SEWAGE DISPOSAL SYSTEM

SUBDIVISION Jefferson Property LOT Tenant House ROAD 18653 Penn Shop Road

S/E ENGINEERING, INC.		
WESTMINSTER		MARYLAND 21157
SCALE: AS SHOWN	APPROVED BY: JDC	DRAWN BY: AES
DATE: JUNE 1993	JOHN M. JEFFERSON 19653 PENN SWAMP RD	
MT. AIRY, MD.	HOWARD CO.	
SANDMOUND	DRAWING NO. 2 OF 2

DATE	6/22/95	JOB NO.
ATTENTION	RON PINKLEY	
RE:	JEFFERSON SAND MOUND

1000 GALLON PUMP CHAMBER ✓ OK
NOT TO SCALE

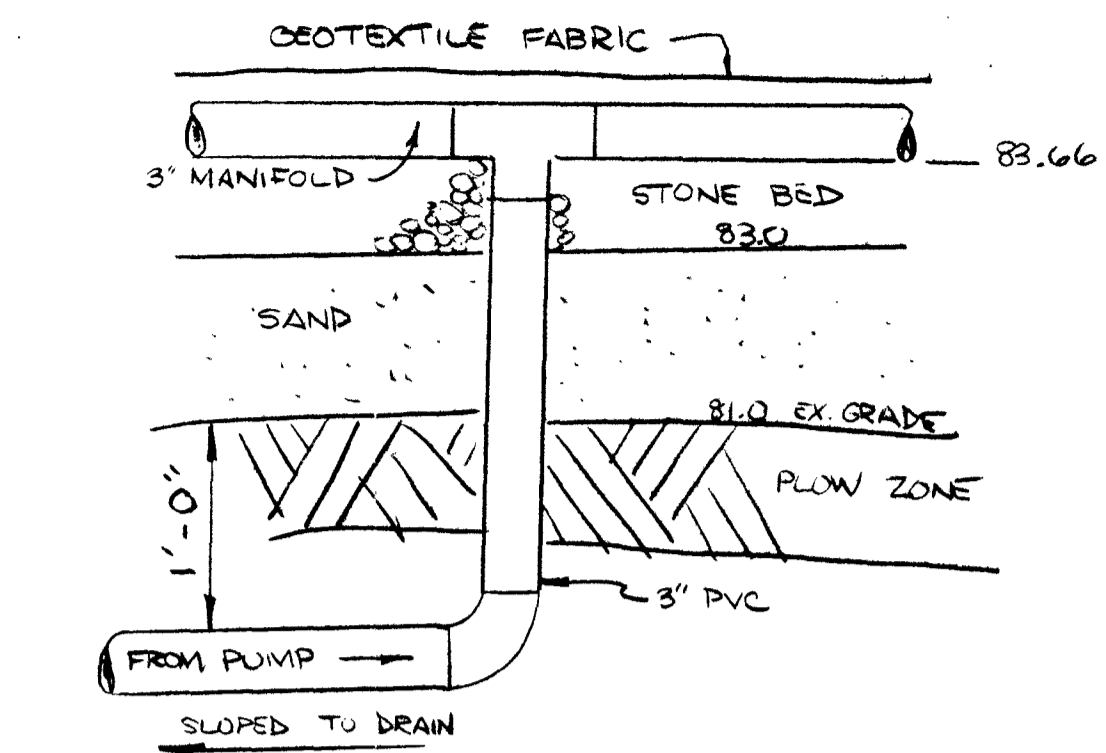
TANK FLOOR - 8' 4" x 4' 9" = 25 GAL / 1" DEPTH

Handwritten notes:
20/15700
1700
1405.64 gal
100
535 OK capacity above high water
down for supply pump system

DESIGN CRITERIA

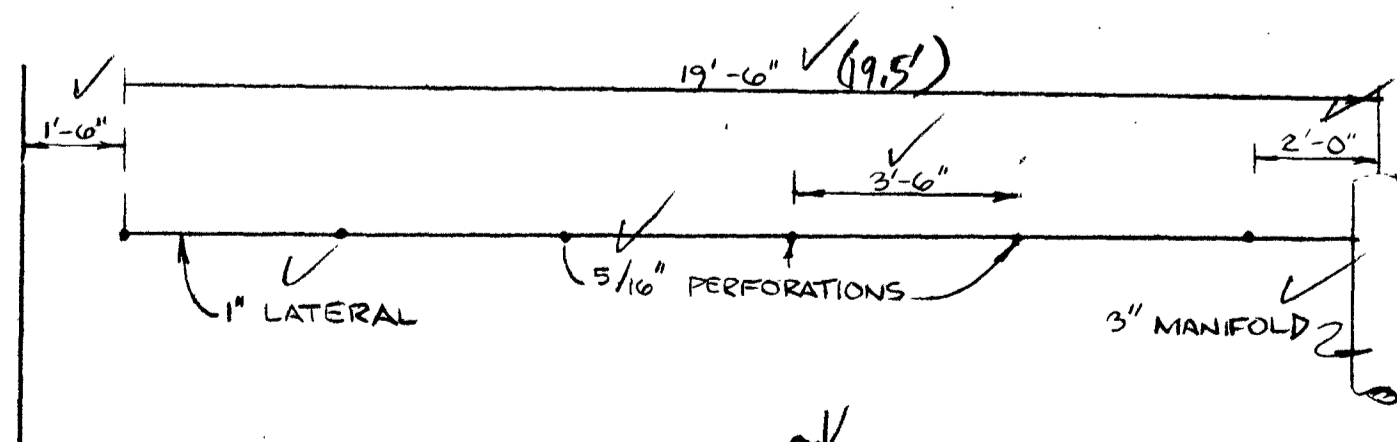
① change 24 - 34.2 ft on Round Dim Spec Sheet

1. On the specification sheet, page 1, order design criteria - correct mound area to read (34' - 2" x 69' - 4").
2. You may delete the detail for OP#4 as there is no perched water table at this site. If the deletion is used, place OP#3 at OP#4's site on the mound layout detail.
3. Reorient the repair mound (nearest TPB) so that it's long axis will be perpendicular to the one shown, for a suggested better orientation to the prevailing contours. (Copy of proposed change enclosed.)

*Above requested changes
were in final plan
received 6/24/93 RJP*

OBSERVATION PIPE DETAILS ✓ OK
NOT TO SCALE

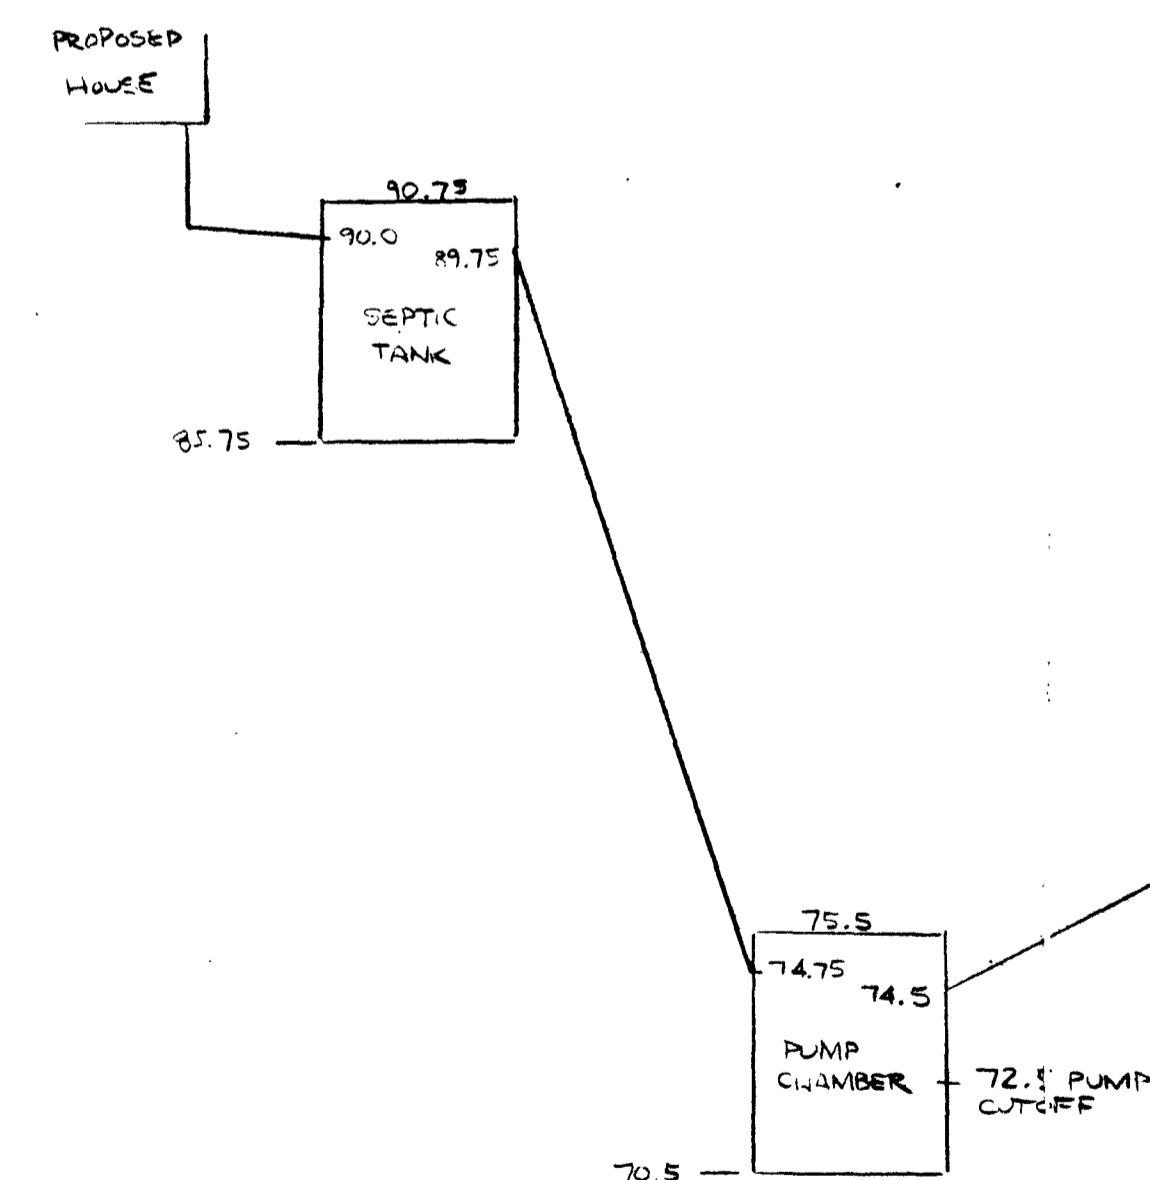
Handwritten notes:
OK, Not 30 Ps
put OP#30 OP#40
in OP#30/40

② ~~may~~ delete detail for OP #4 - place OP #3 @ OP #4 location
on Round Layout Detail

SITE PLAN/HORIZONTAL ALIGNMENT
SCALE: 1" = 30' actual shown to 40' detail

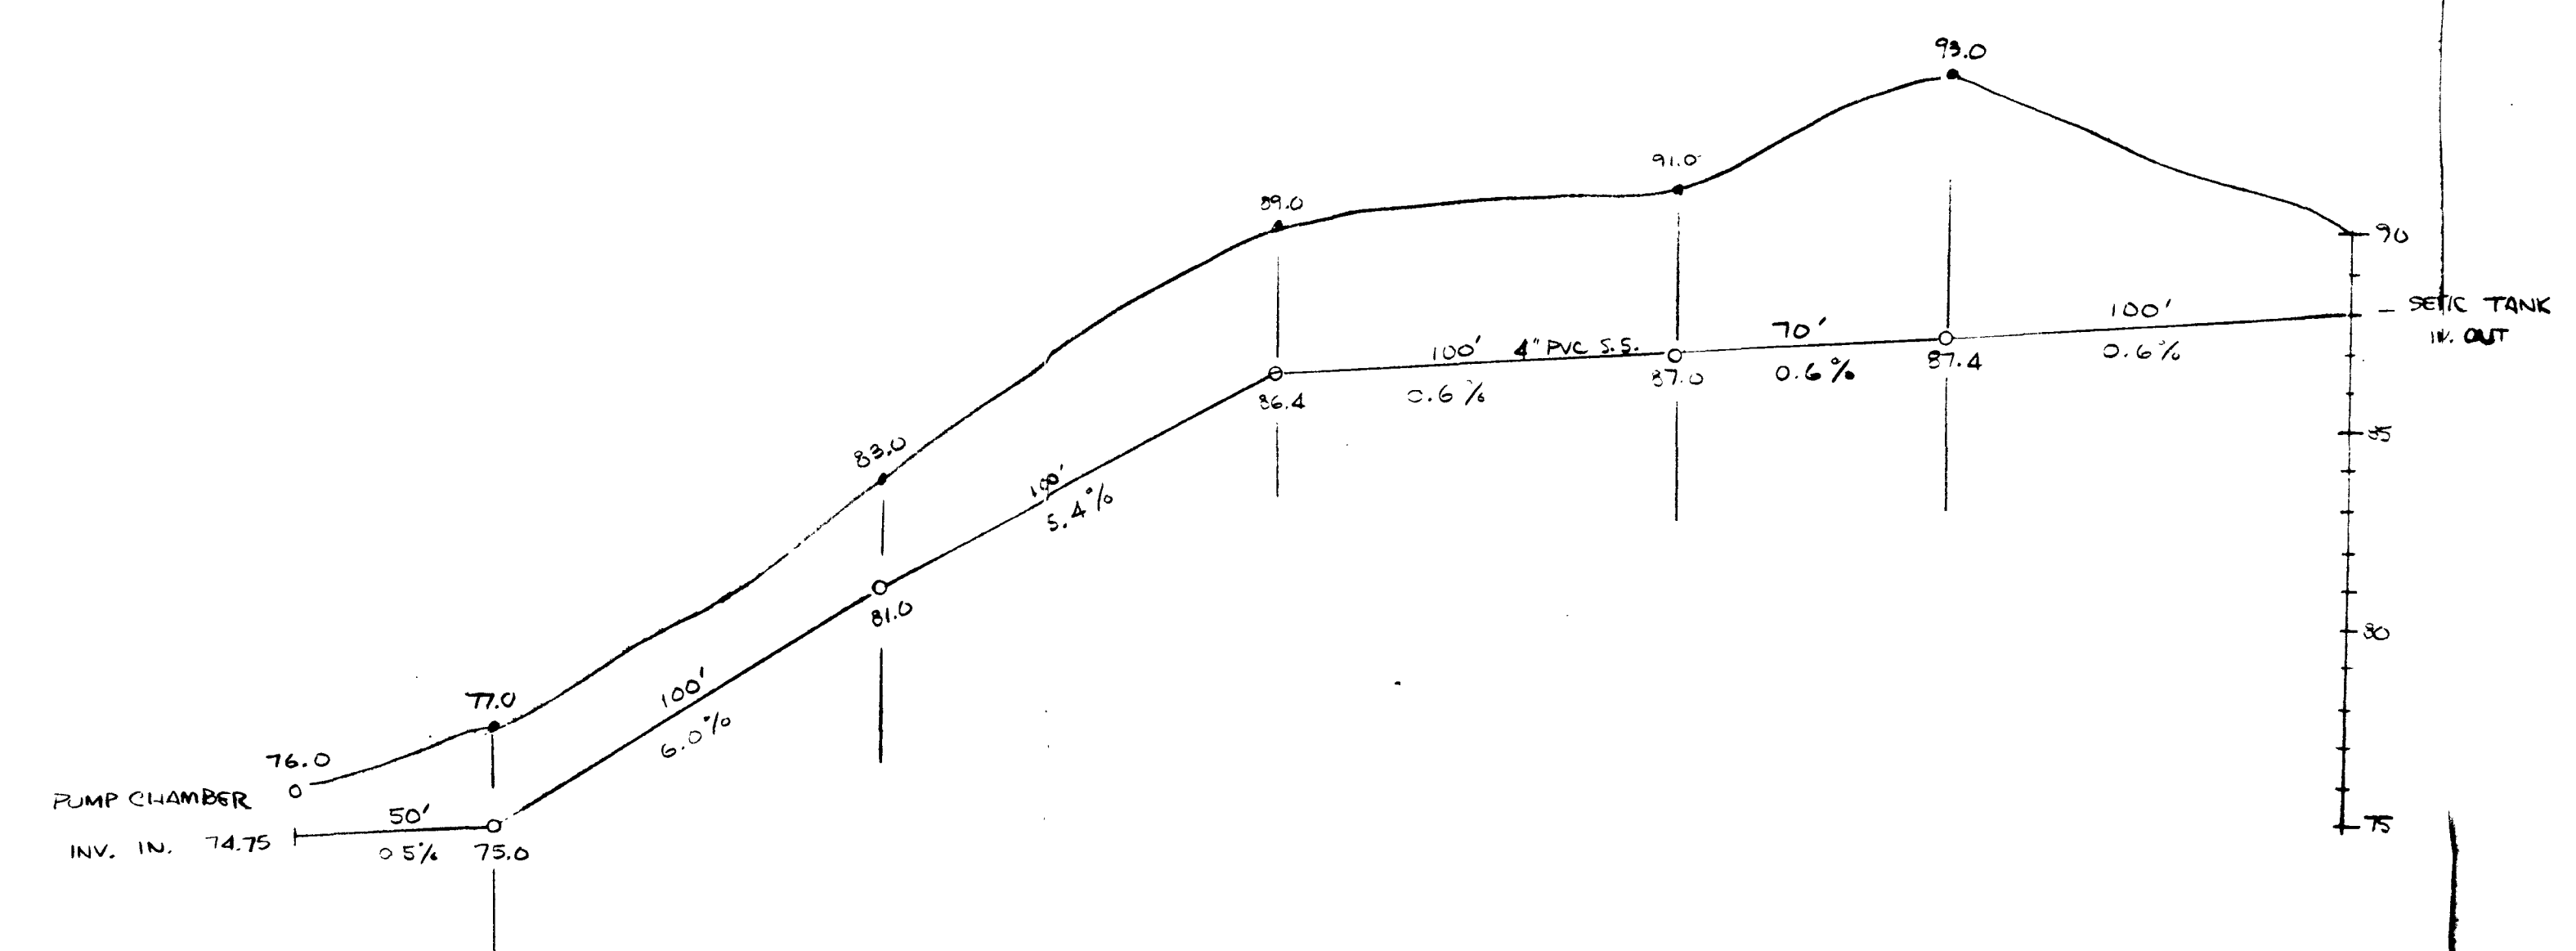
③ Site Plan copy measures closer to 1:80 scale
